## Addendum No. 2

DATE:	Monday, June 24, 2019
PROJECT:	City of Pharr/PSJA Aquatic Facility
PROJECT NO:	971805/ 1819-35-510-C011-051
LOCATION:	3001 N. Cage Blvd., Pharr, Texas 78577
FROM:	Laura N. Warren, The Warren Group Architects, Inc.

P1.04

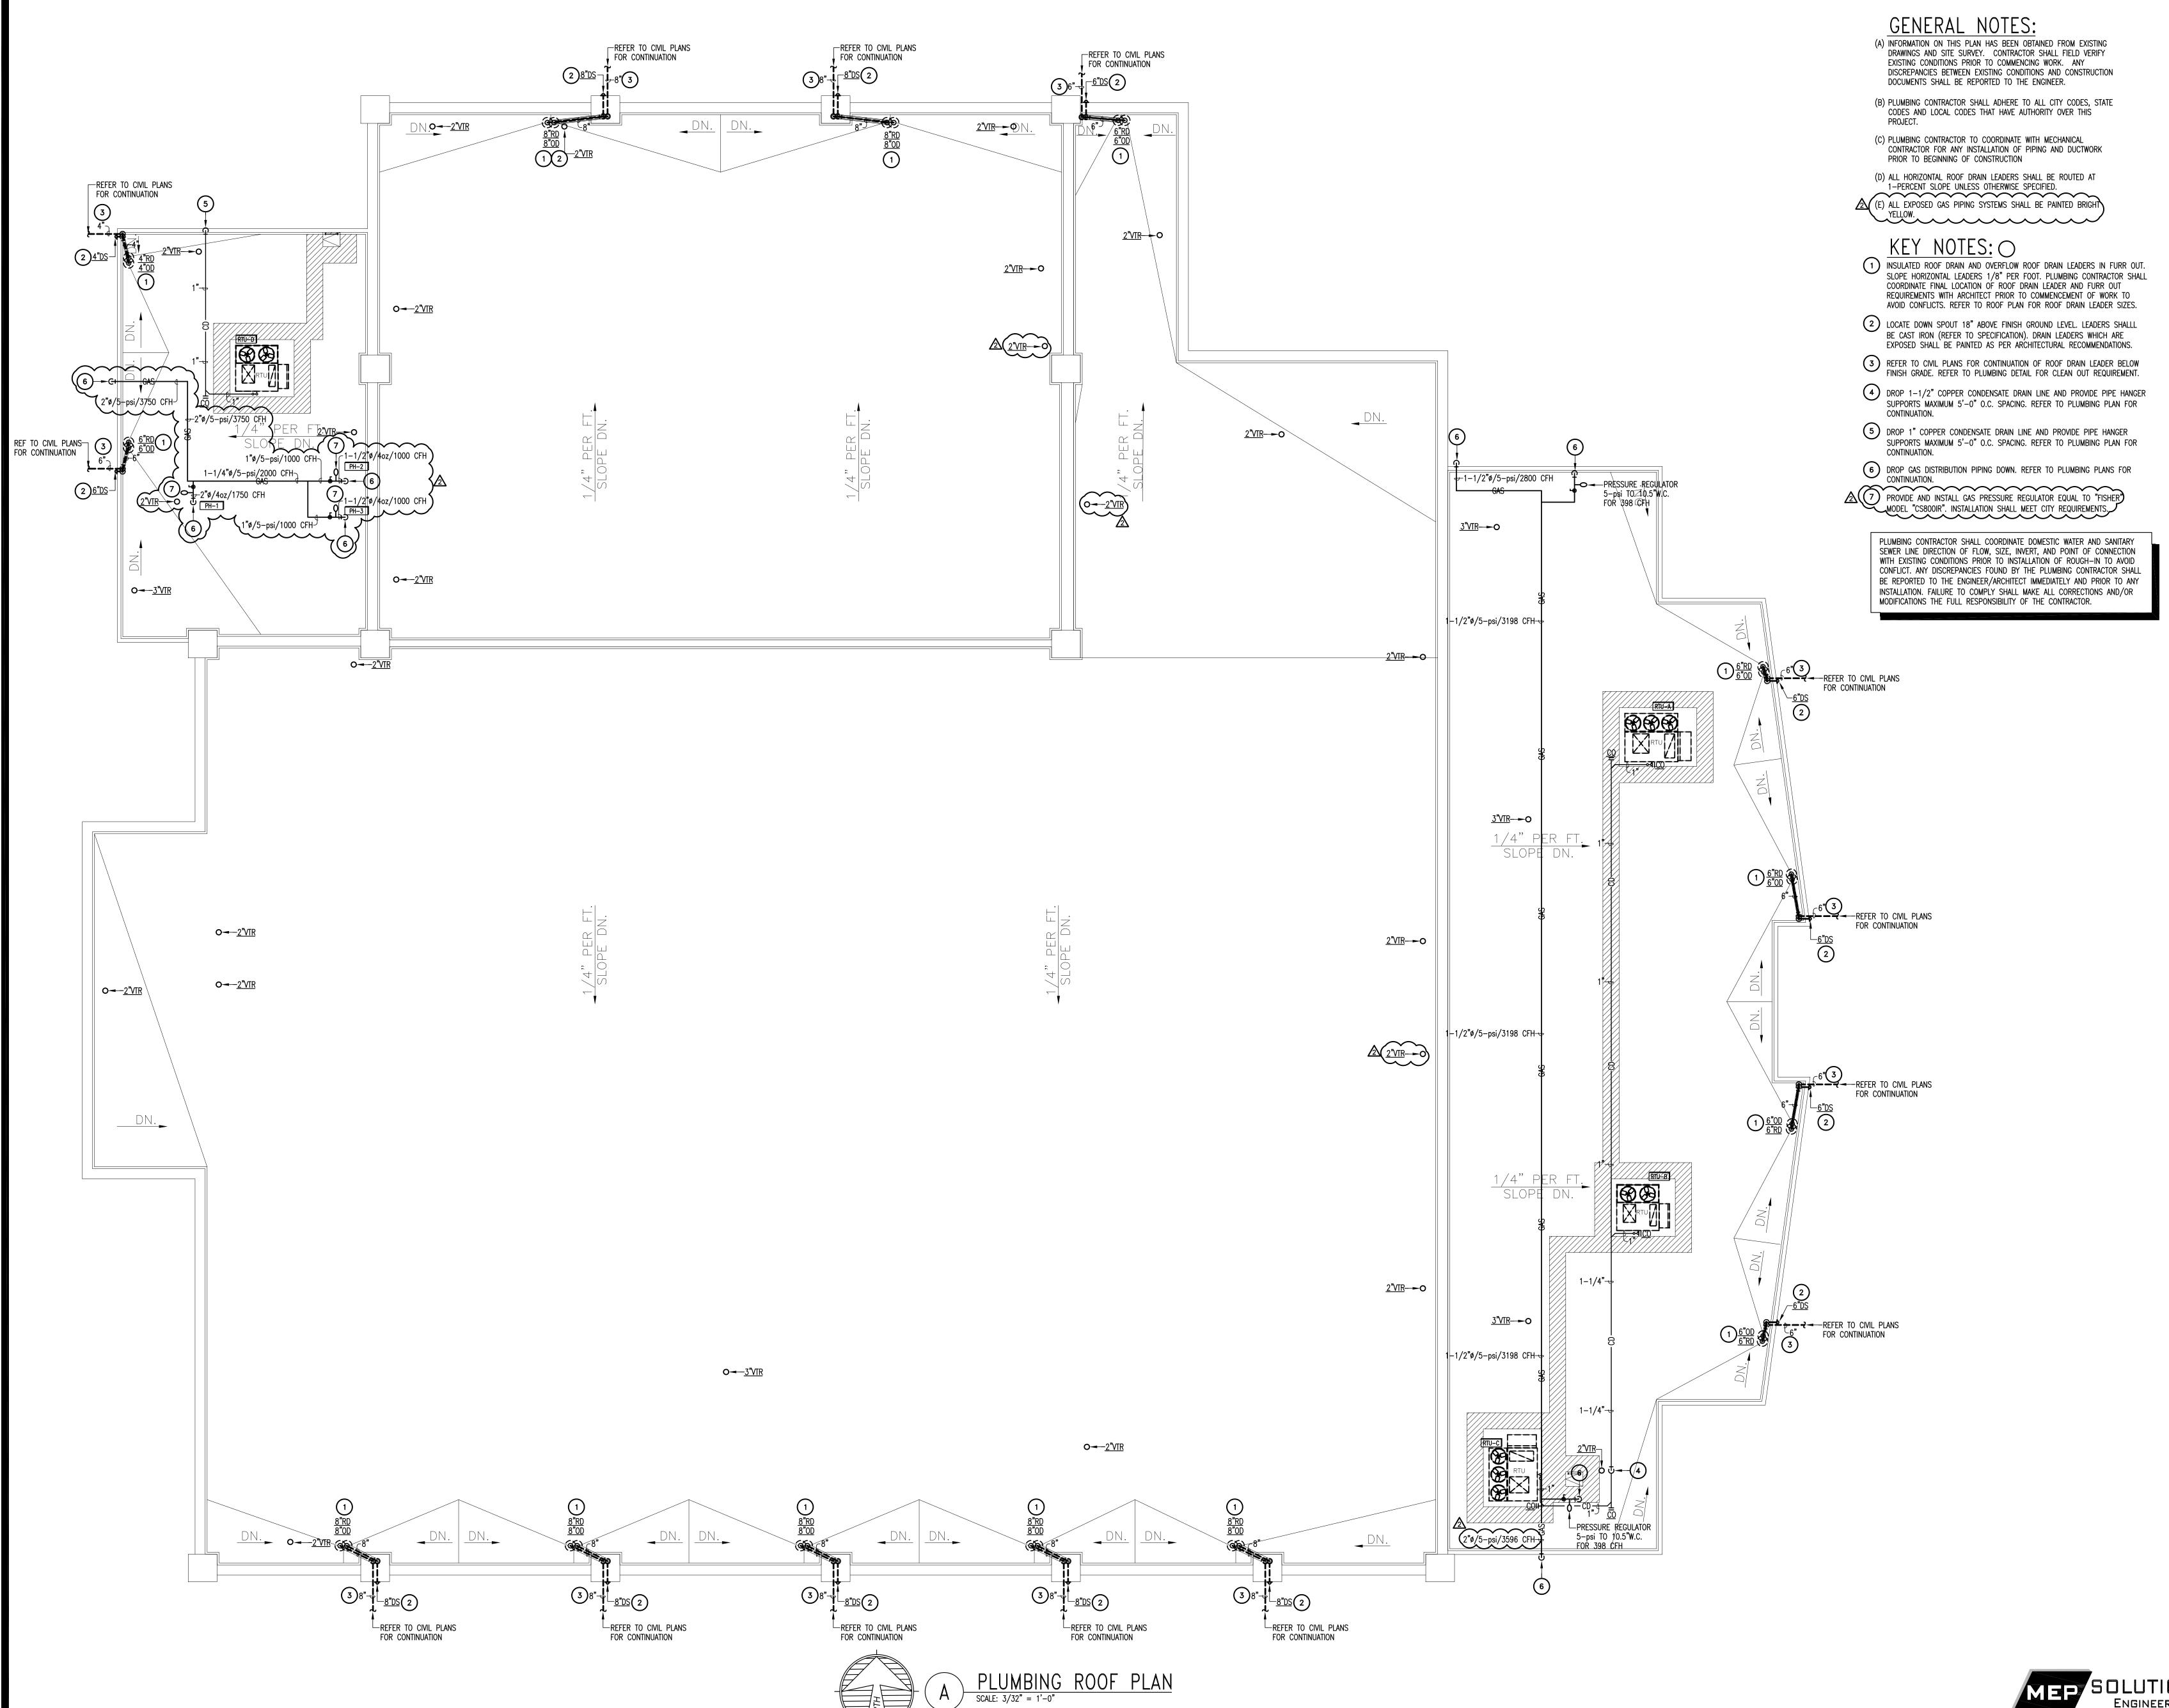
- Item No. 39: Refer to Construction Documents dated June 7, 2019. MEP Plumbing HW/CW mezzanine plan has additional information included. Refer to 30x42 sheet P1.04 ADD2 dated 6/21/2019.

S101

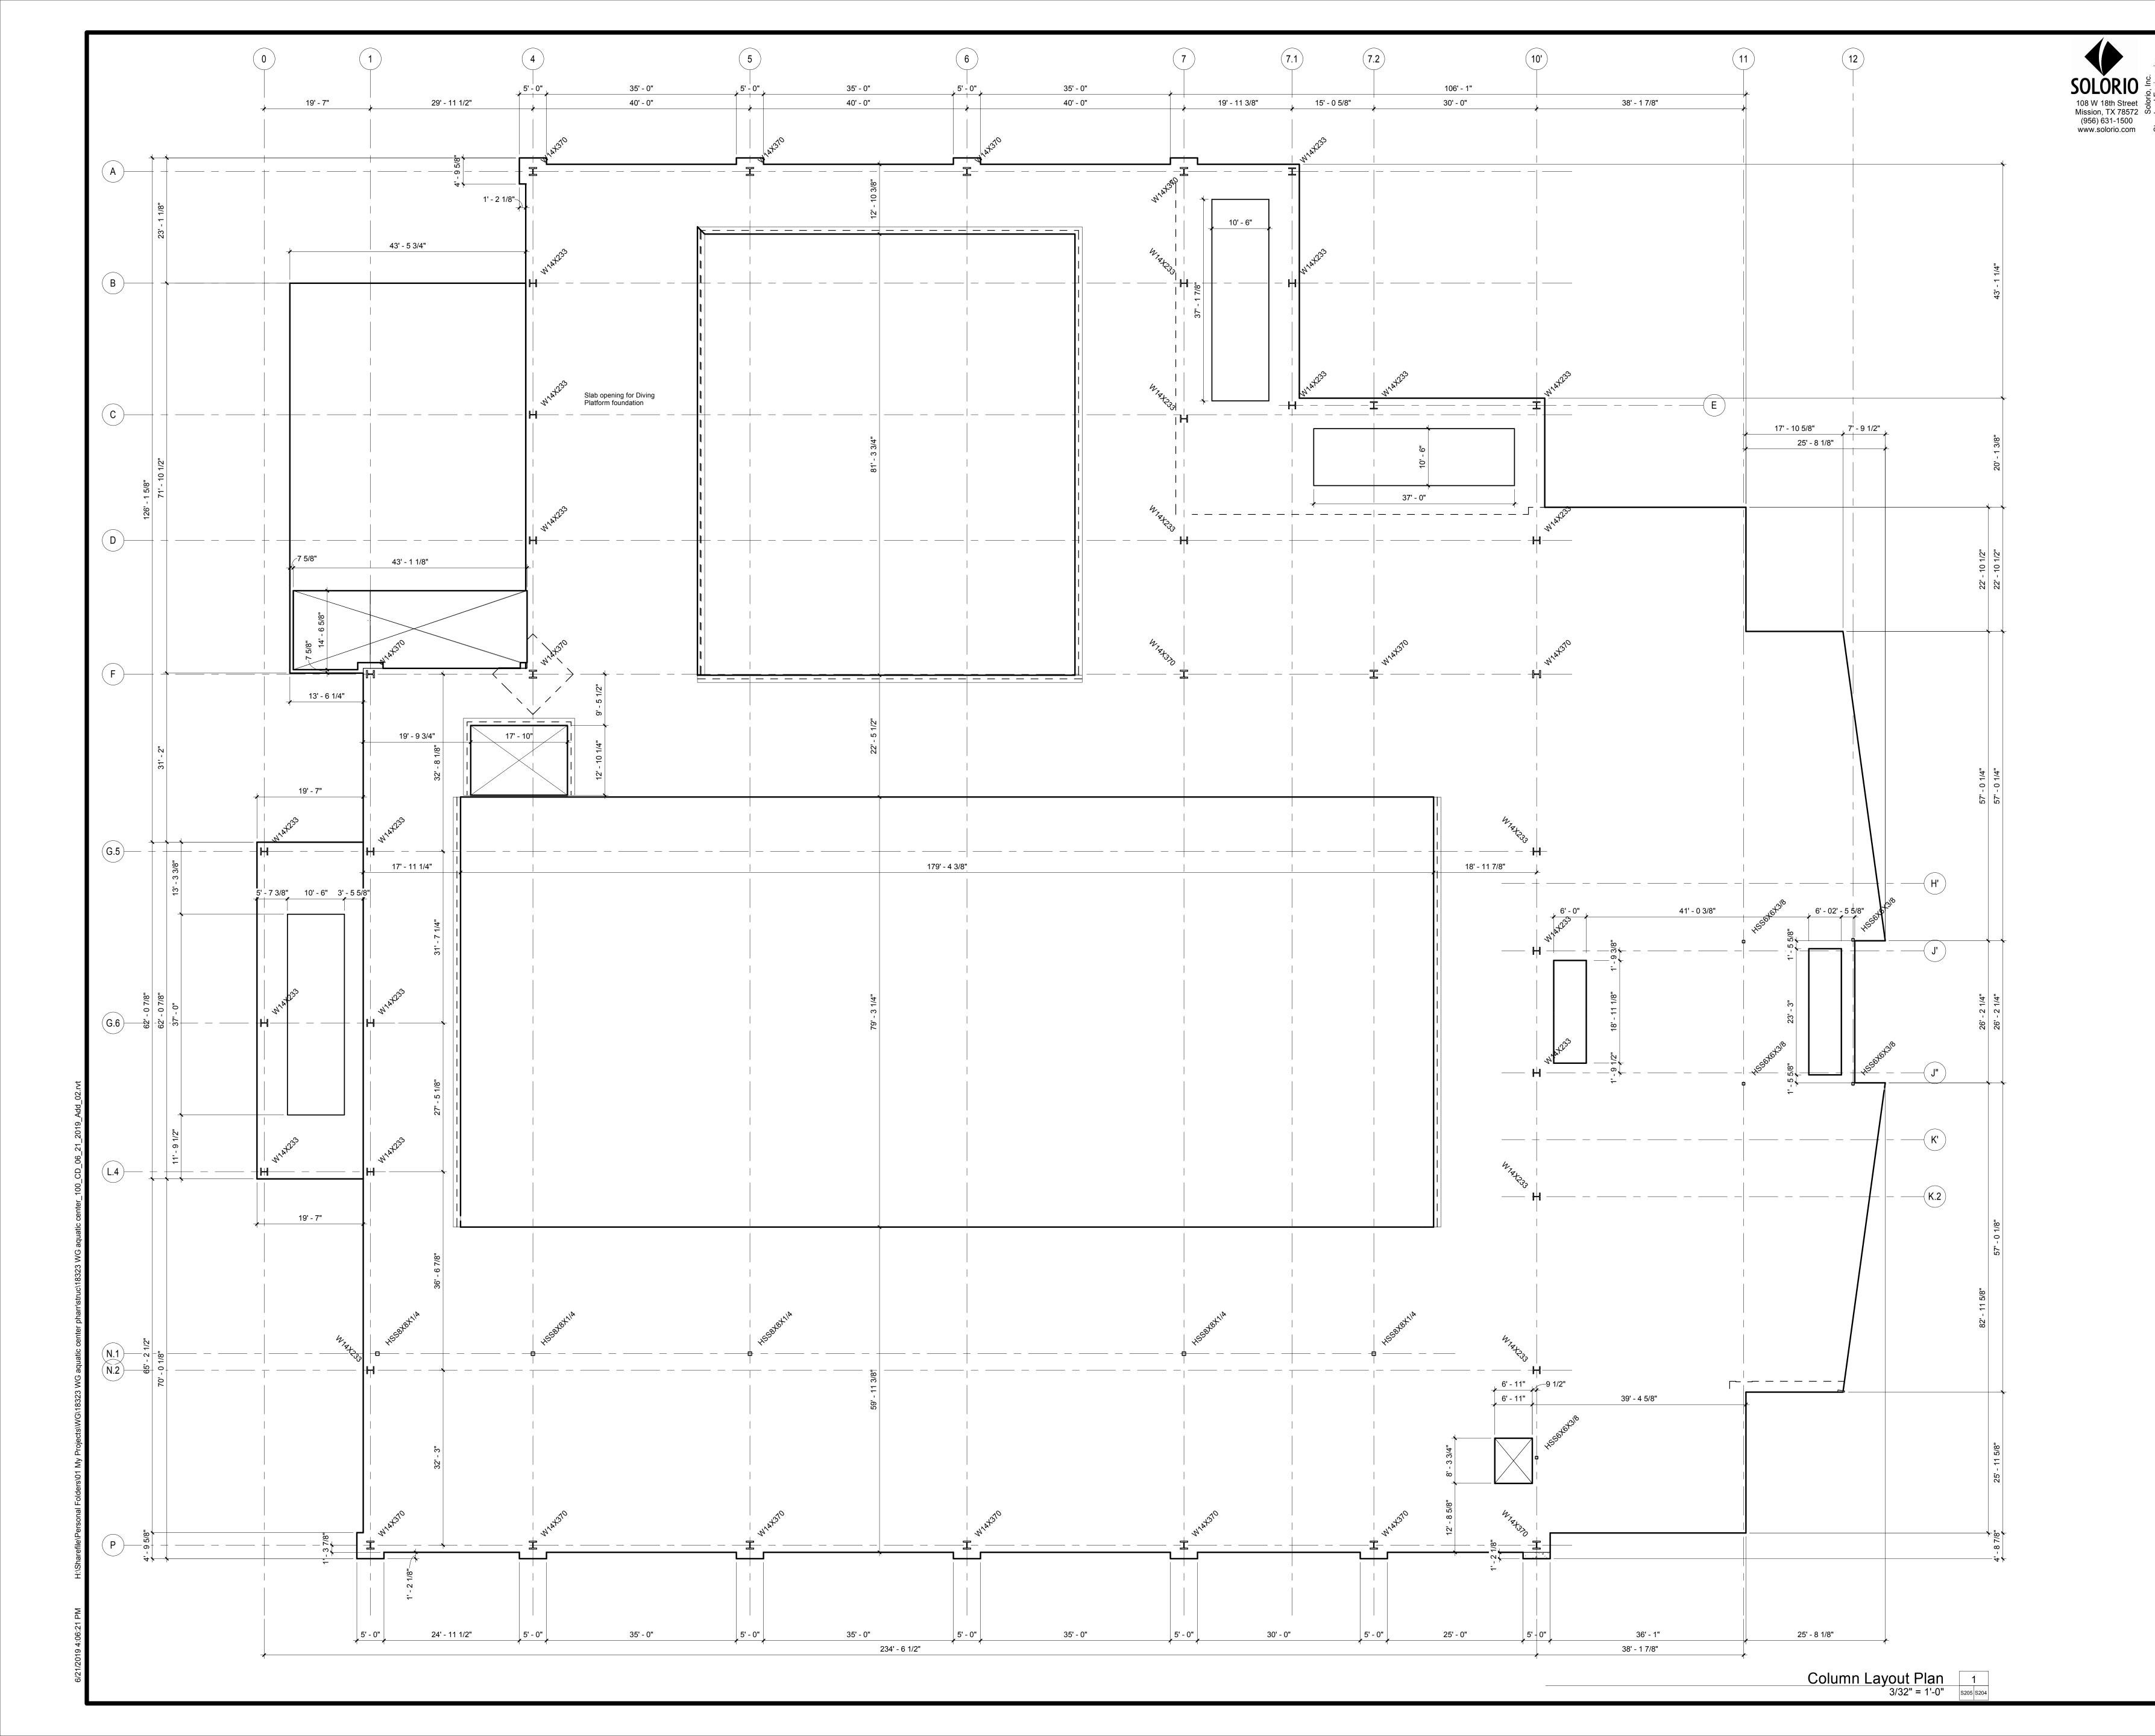
- Item No. 2: Refer to Construction Documents dated June 7, 2019. STRL General Notes has additional information included. Refer to 30x42 sheet S101 dated 6/21/2019.
- Item No. 3: Refer to Construction Documents dated June 7, 2019. STRL Column Layout Plan has new modifications including concrete slab for heavy air handling units. Refer to 30x42 sheet S204 dated 6/21/2019.
- Item No. 4: Refer to Construction Documents dated June 7, 2019. STRL Misc Structures has additional information including mechanical pad section. Refer to 30x42 sheet \$205 dated 6/21/2019.
- Item No. 5: Refer to Construction Documents dated June 7, 2019. STRL Foundation Details has additional information including stair reinforcing and flag pole pier schedule for 45 ft flags. Refer to 30x42 sheet \$432 dated 6/21/2019.

S453

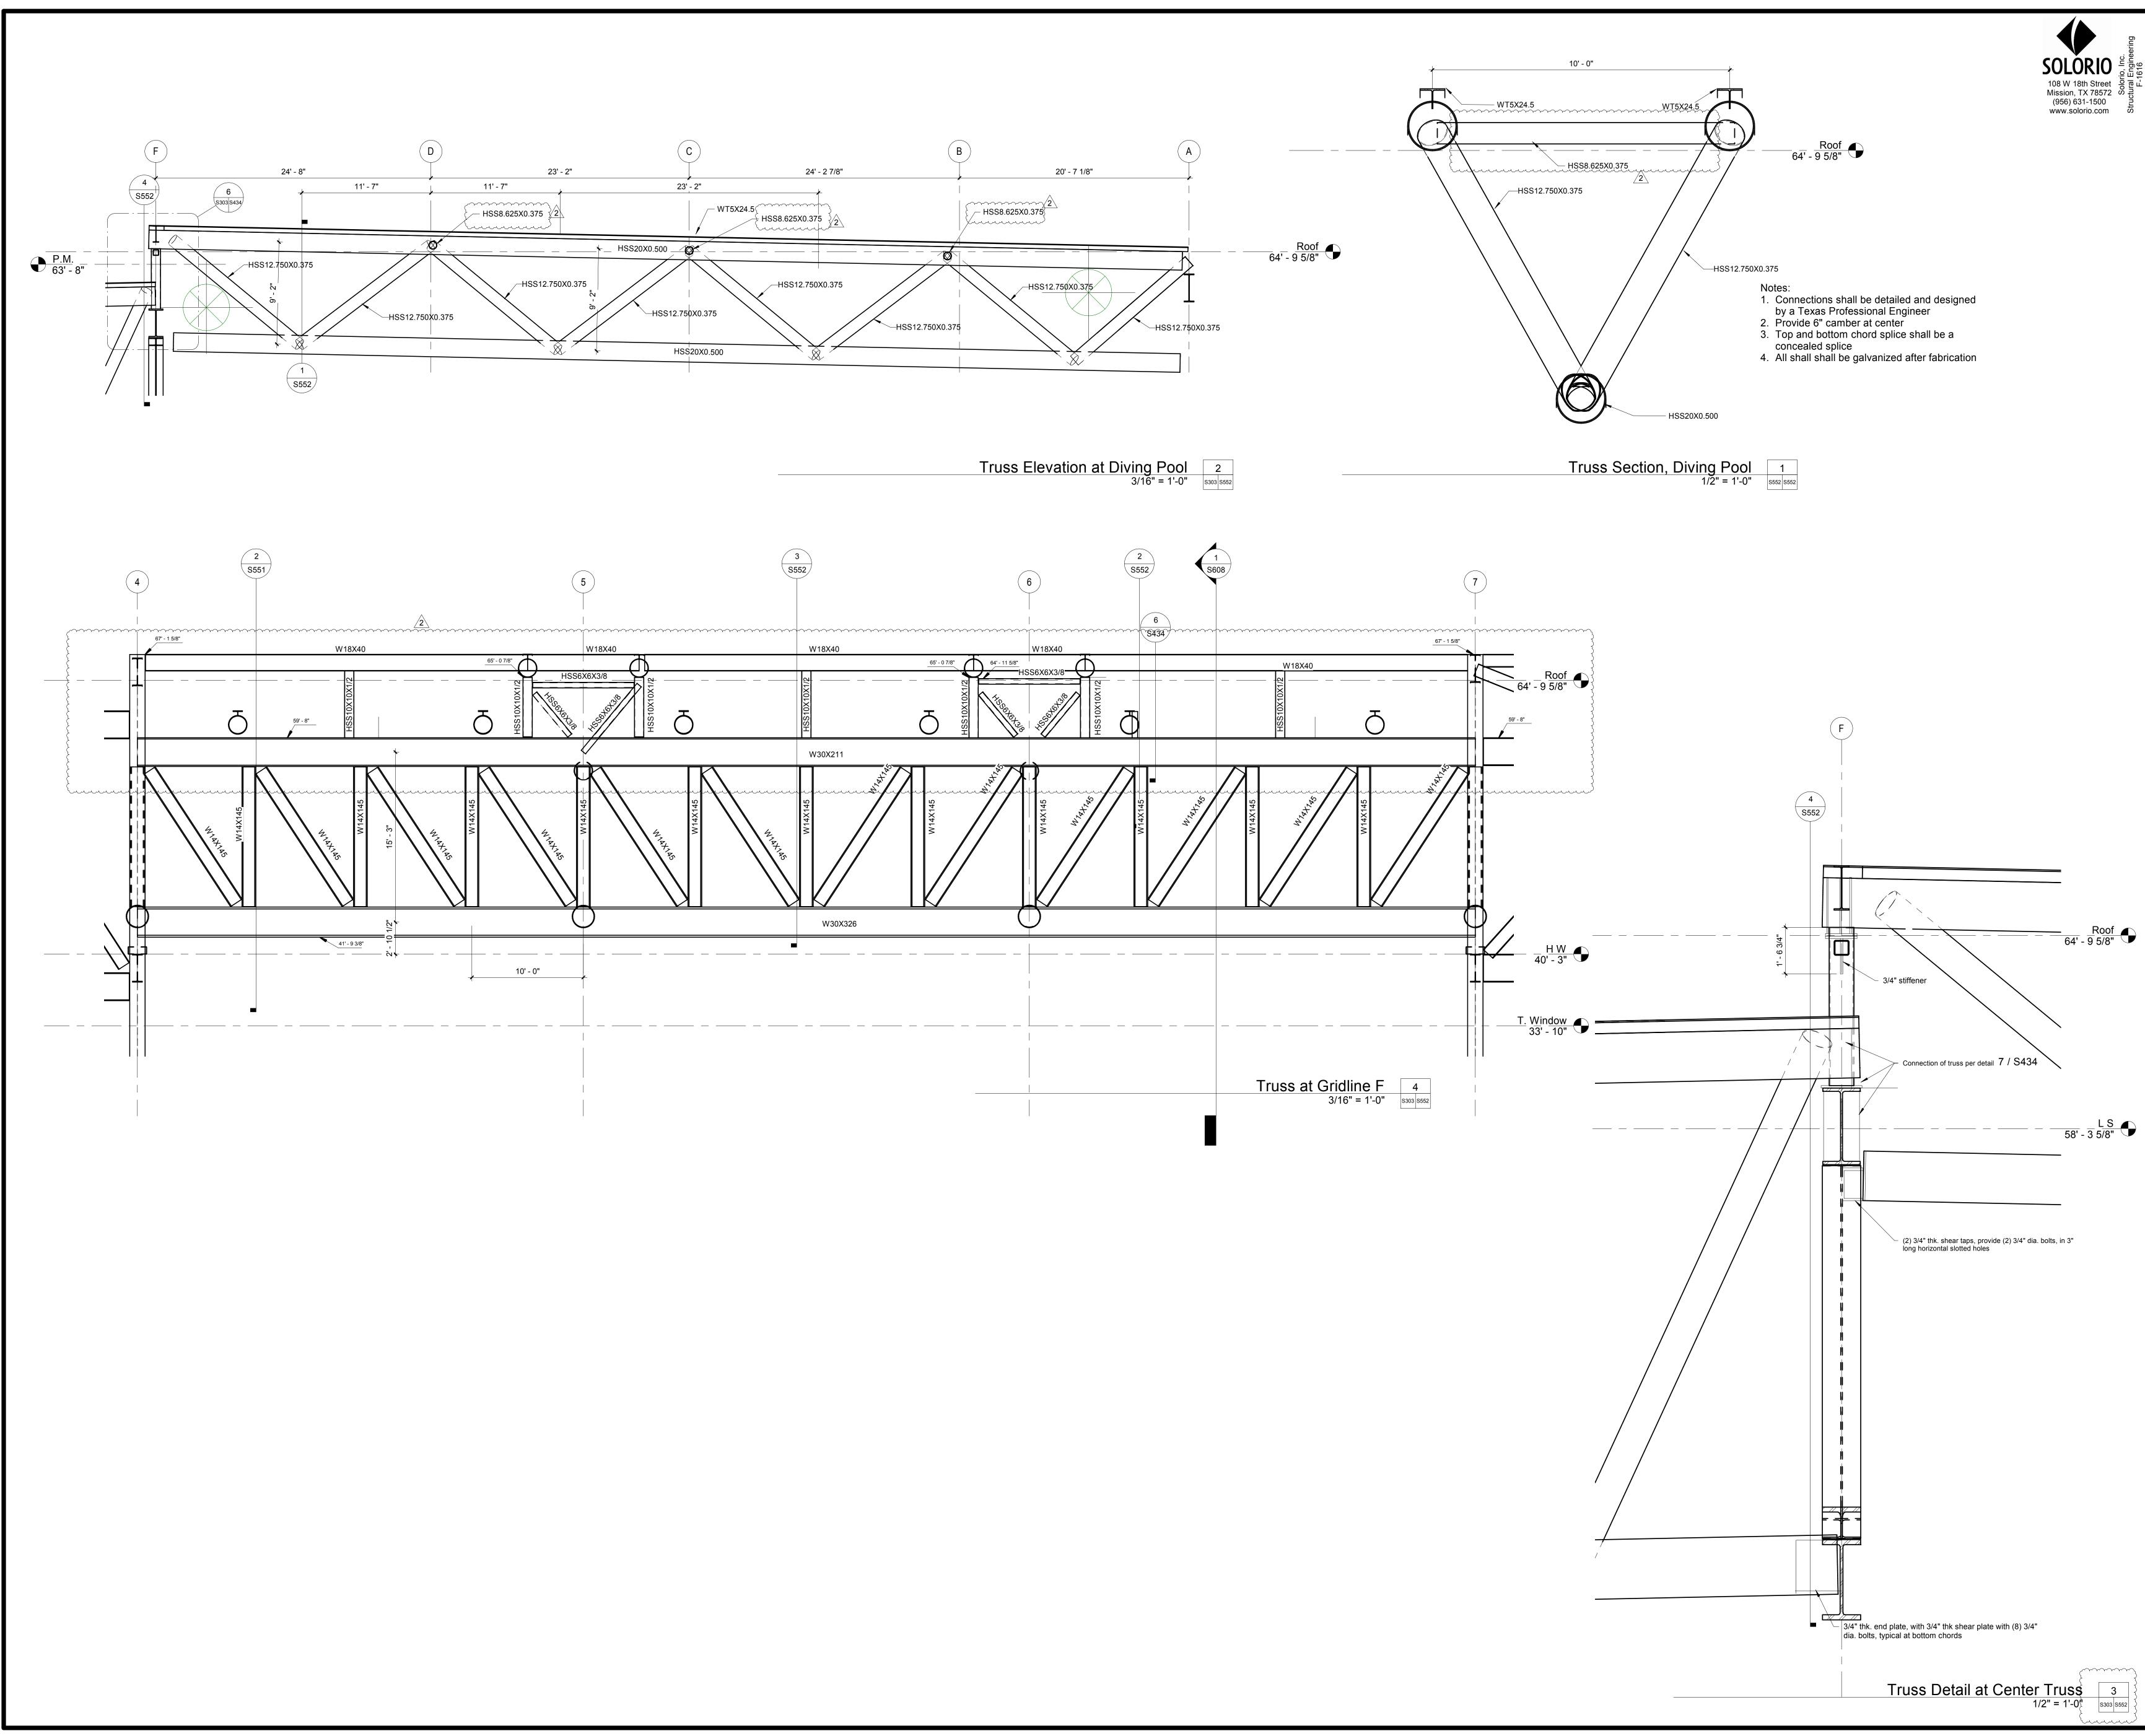
- Item No. 8: Refer to Construction Documents dated June 7, 2019. STRL Typical Details has additional information included. Refer to 30x42 sheet S453 dated 6/21/2019.
